S-SB-0041-13

Taillight Lens Cracking

REVISION NOTICE

Figure 1.

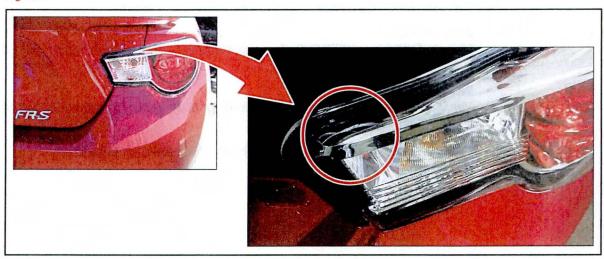
1. Confirm the upper surface of the lens in the rear combination light is cracked.
